From: [Wolfenbarger, Jeanne](#)
To: ["Vinny Perea"](#)
Subject: Freddy's (Formerly Whataburger)
Date: Monday, June 01, 2015 4:37:00 PM

RE: **Whataburger
Grading Plan
Engineer's Stamp Date 2-18-2015 (File: K10-D001B)**

**RE: FREDDY'S (PREVIOUSLY WHATABURGER), 111 COORS BLVD. NW
GRADING AND DRAINAGE PLAN
ENGINEER'S STAMP DATE 2-18-2015 (K10-D001B)**

**FREDDY'S AT
COORS AND CENTRAL
GRADING AND
DRAINAGE PLAN**

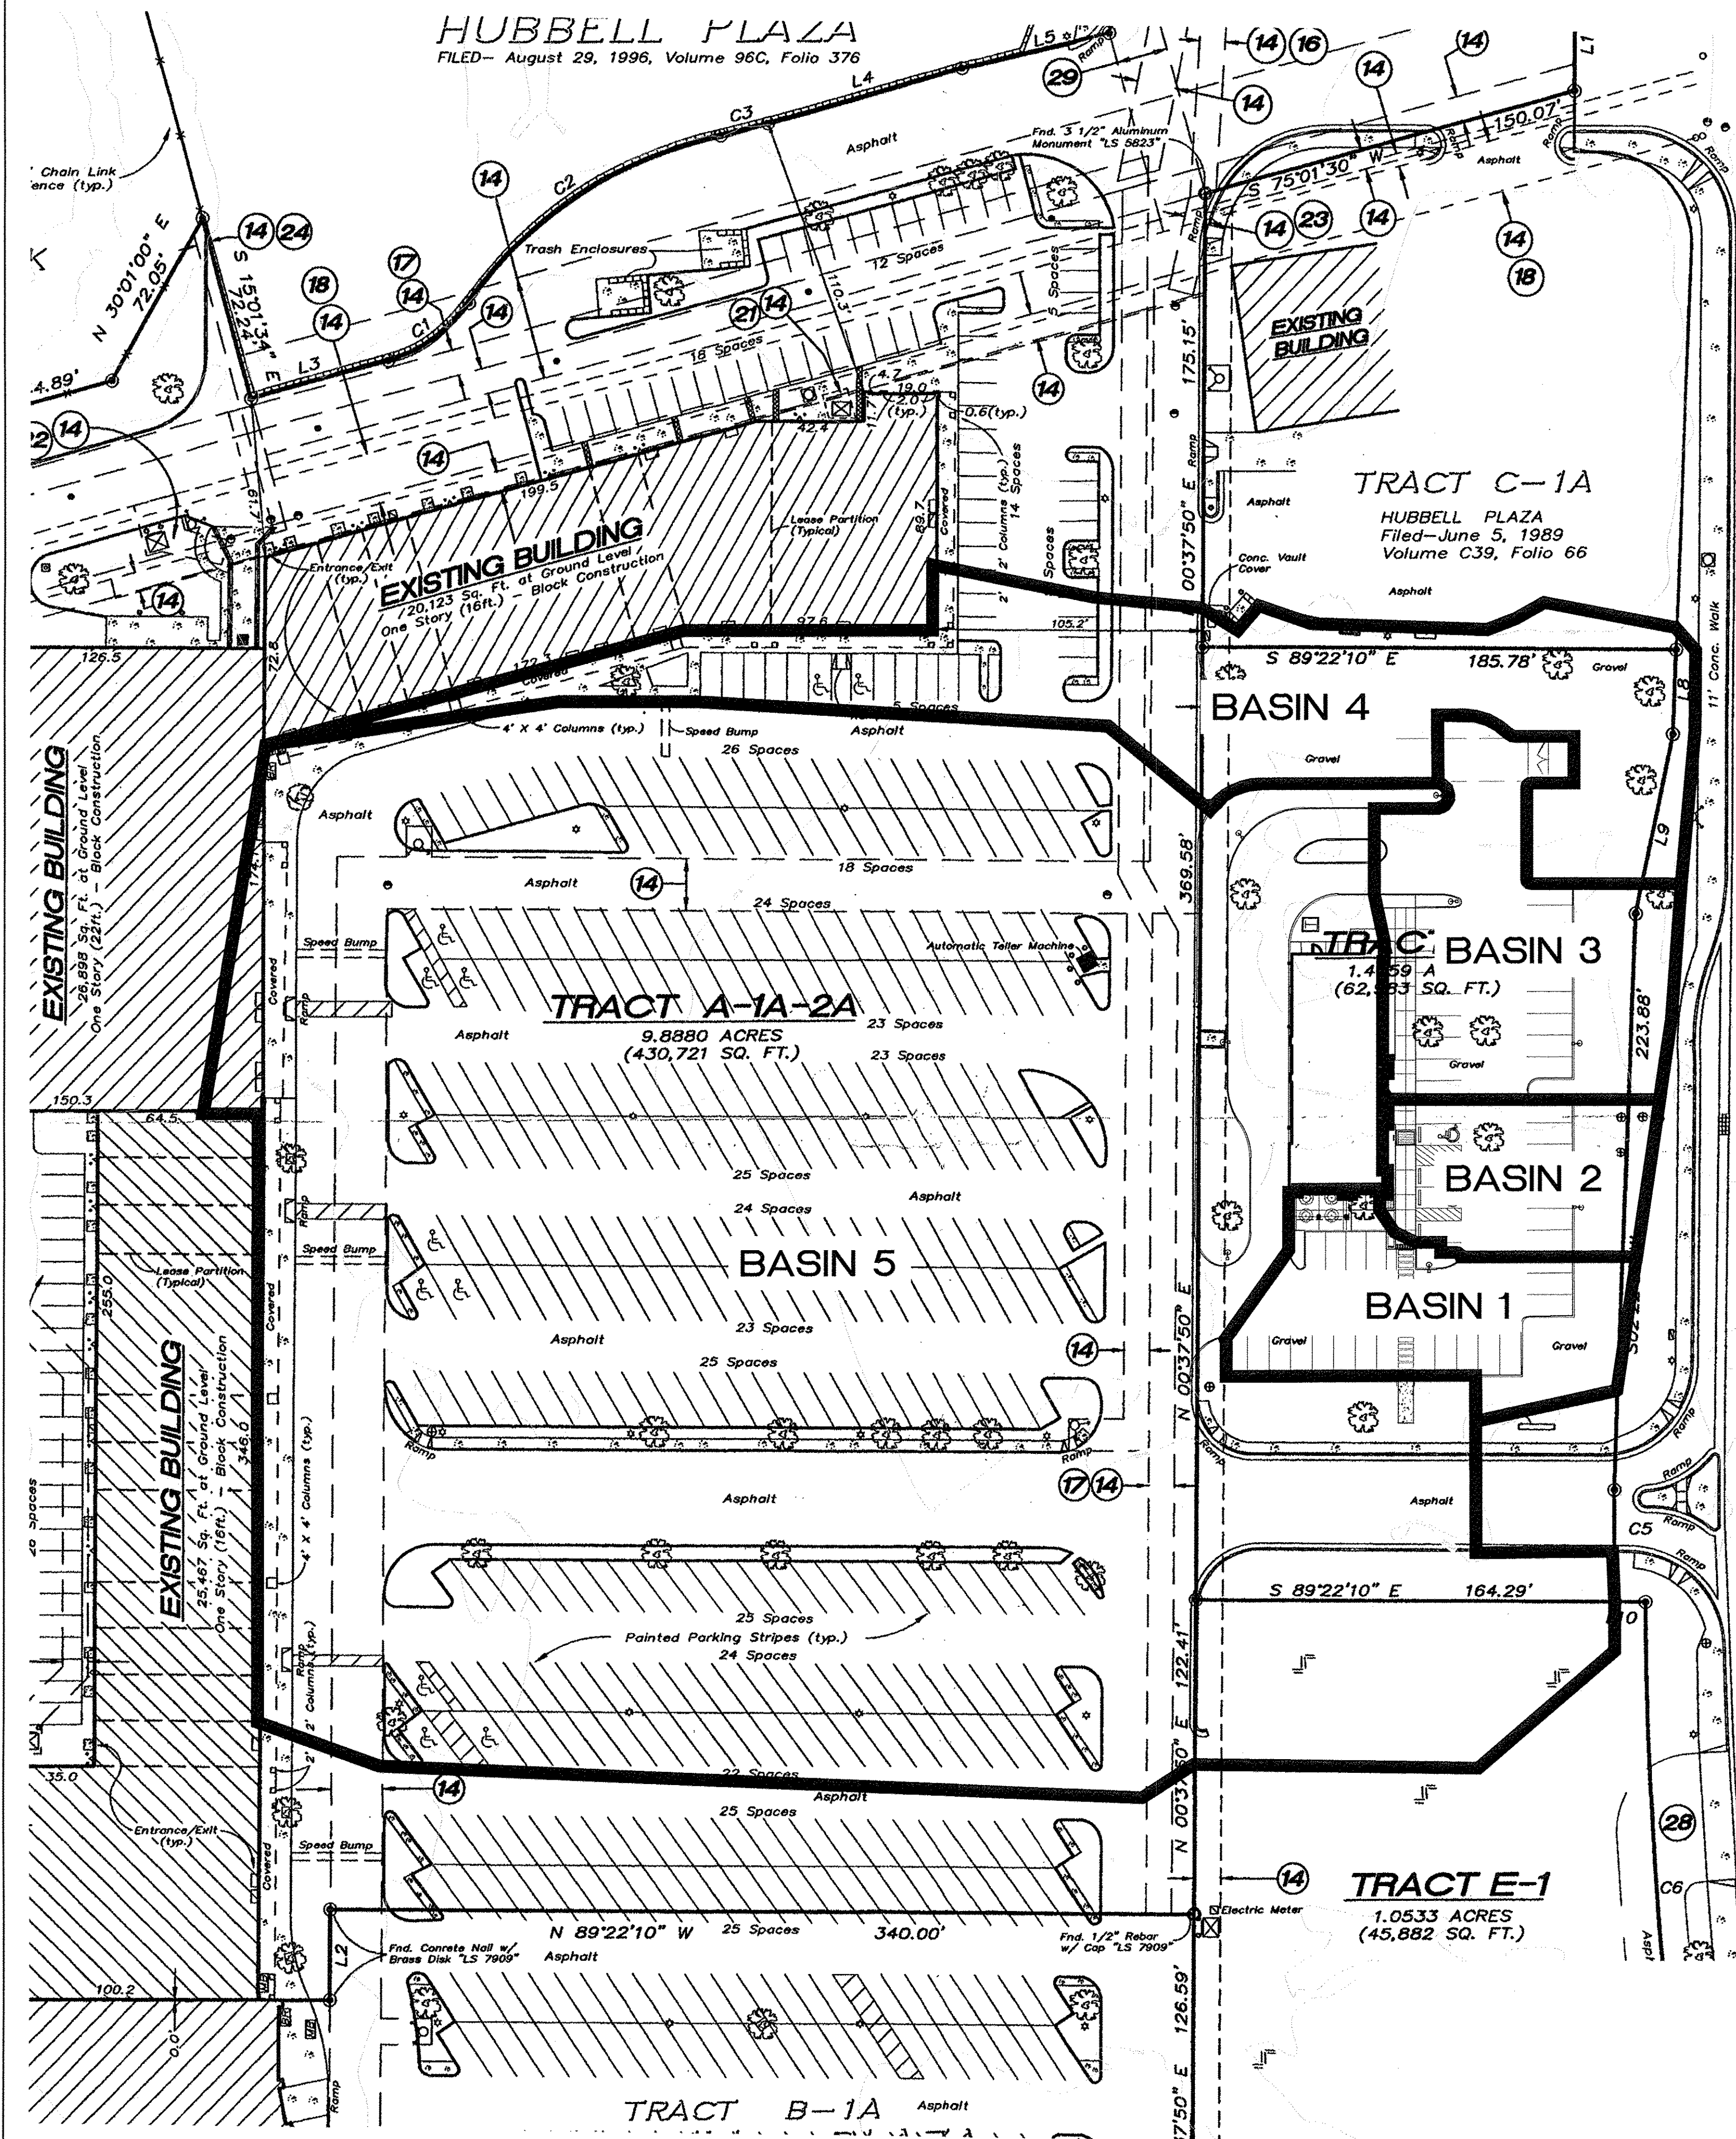
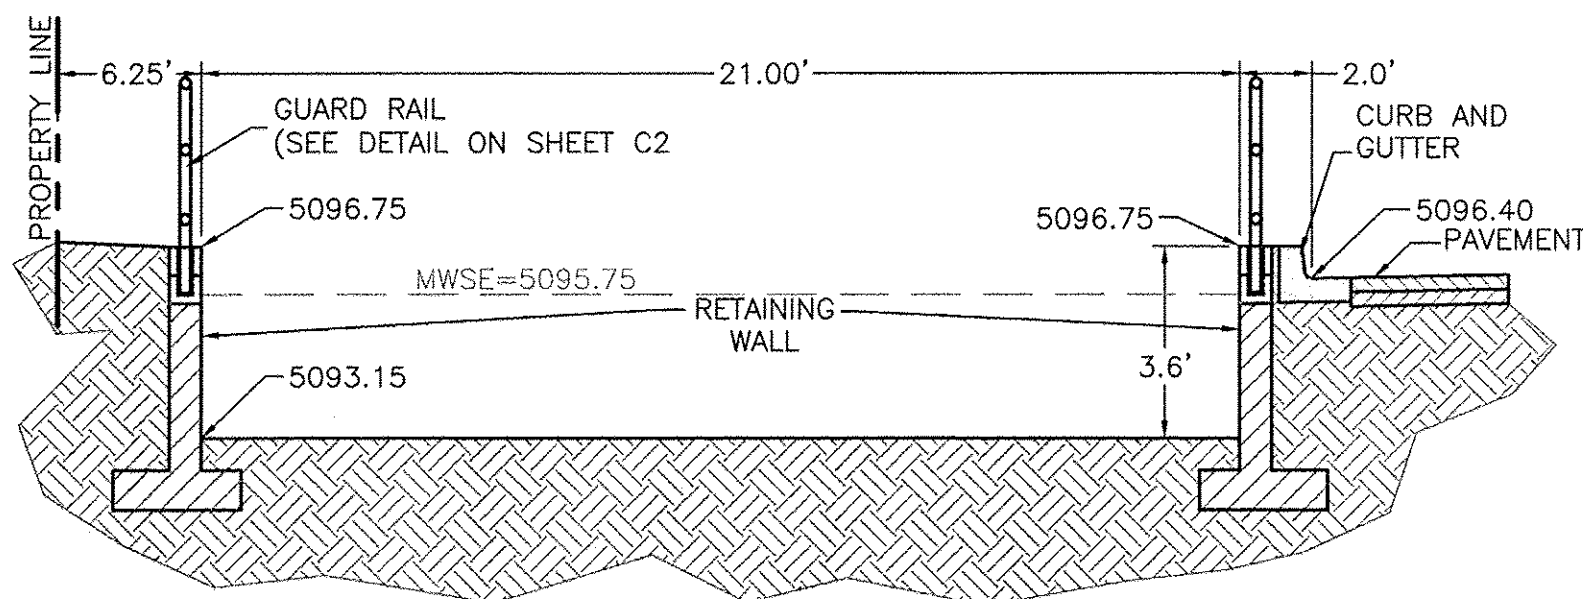
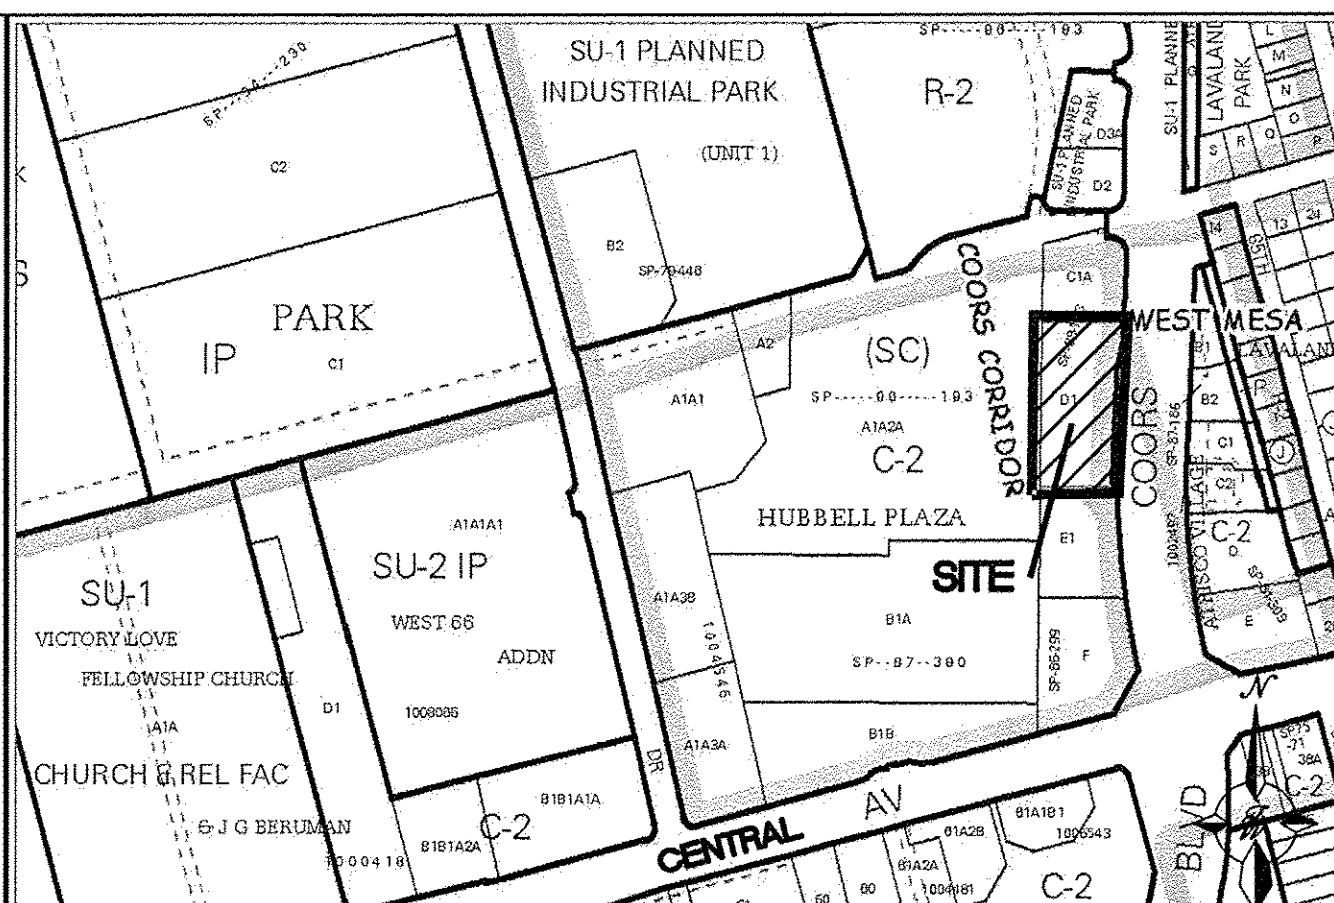
- A. An agreement from adjacent property owner to the west acknowledging the increase in 100-year water surface elevation to what is shown on the plan at a distance of "X" above existing ground.
- B. Put back the spot elevations that you had on the conceptual plan showing the relationship between top of water surface elevation and top of existing ground. Ensure that the added water surface depth does not adversely affect the property to the north or south and that drainage is still being directed toward the double "D" inlet.
- C. Add a grease trap connection for the dumpster with a couple of added spot elevation showing drainage to the grease trap.

- 2) On the plan view for the "Grading and Drainage Plan", label all of the different detention volumes that correspond to the "Proposed Conditions" discussion which include the 0.43 ac-ft detention pond, the 0.16 ac-ft surface pond, and the underground storage of 0.22 ac-ft. Show the underground storage system area on the plan view for the "Grading and Drainage Plan", and label the connections from the new 24-inch storm drain to this underground storage system.

- 3) There is a Section A-A on the "Grading and Drainage Plan" which shows pond elevations within the detention pond in the north area of the site. Provide more spot elevations within this area at the corners of the pond to ensure that there will be enough volume provided for the detention pond.

- 4) Eliminate the existing timed butterfly valve as discussed. If there are issues with the valve not operating properly, it will pose a risk to the site. The pipe discharging from the site to Coors Boulevard is at the upstream end of the existing storm drainage system, and it is discharging to a fairly steep 18-inch pipe in Coors Boulevard to convey the required 1.08 cfs. Therefore, due to the amount of existing

- 5) How is storm drainage getting to the Double-D inlet on the west side of the site? Provide capacity calculations for the 5.6-foot wide curb cut that is accepting the off-site flow from the west and adjust as necessary.

- 8) It is not clear if the subject site is accepting off-site flows from the site or how the site to the north will be impacted. Include discussion of off-site flows from the site to the north to ensure that grading of the Whataburger site does not adversely impact this site.

3. There is a Section A-A on the "Grading and Drainage Plan" which shows pond elevations within the detention pond in the north area of the site. Provide more spot elevations within this area at the corners of the pond to ensure that there will be enough volume provided for the detention pond.

4. Eliminate the existing timed butterfly valve as discussed. If there are issues with the valve not operating properly, it will pose a risk to the site. The pipe discharging from the site to Coors Boulevard is at the upstream end of the existing storm drainage system, and it is discharging to a fairly steep 18-inch pipe in Coors Boulevard to convey the required 1.08 cfs. Therefore, due to the amount of existing pipe capacity to handle such a small amount of flow, there is no concern regarding elimination of the timed valve.

5. How is storm drainage getting to the Double-D inlet on the west side of the site? Provide capacity calculations for the 5.6-foot wide curb cut that is accepting the offsite flow from the west and adjust as necessary.

8. It is not clear if the subject site is accepting off-site flows from the site or how the site to the north will be impacted. Include discussion of off-site flows from the site or how the site to the north will be impacted. Include discussion of off-site flows from the site to the north to ensure that grading of the Whataburger site does not adversely impact this site.

Response: The detention volumes for surface ponding and the detention pond have changed slightly and were accounted for in the narrative discussion and calculations, still equating to the total 0.81 ac-ft of total storage. Detention volumes were added to each label calling out the maximum water surface elevations for the surface and detention ponding areas. The two surface ponding areas show ponding areas show 0.08 ac-ft and 0.15 ac-ft volumes for each, equating to the total 0.23 ac-ft for surface ponding. The north detention pond shows the volume to be 0.36 ac-ft. The underground storage system was hatched and called out on the "Grading and Drainage Plan" Sheet, the detention volume was added to this label as well (0.22 ac-ft). The two 24-inch storm drains that connect to the underground storage were labeled and show the invert elevations of where each connects.

Response: Top of Wall and Bottom of Wall spot elevations are called out at the corners of the north area detention pond on the "Grading and Drainage Plan" sheet.

Response: The relocation of the existing timed butterfly valve was removed from the plan set on the "Grading and Drainage Plan" sheet, showing the valve to be removed completely from the site.

Response: Storm drainage on the west side of the building/site is directed towards the landscaped area, away from the building. This drainage is directed towards the Double D inlet through a series of 1 foot curb cuts along the east curb of this landscaped area, the locations of the cuts are marked on the "Grading and Drainage Plan" sheet as keyed note 7. Capacity calculations for the curb cut accepting offsite flows from the west were added to the "Basin Map and Calculations" sheet. For the given offsite flows, the curb cut width needs to be 16.2 feet wide. The grading plan was modified for this change and concrete bollards were added within the curb cut to prevent vehicles from entering.

Response: Flows from the site to the north are not affected by the development of our site. The curb along the southern end of the north site acts as a basin boundary between Basin 4 (onsite) and the northern tract basin (offsite). Flows south of this curb will be directed towards the onsite detention pond and is included in the drainage volume calculations. Flows north of this curb are directed west towards the shopping center access road and then flow north away from our site. Discussion of this was added to the "Existing Conditions" of the narrative on the "Grading and Drainage Plan" sheet.
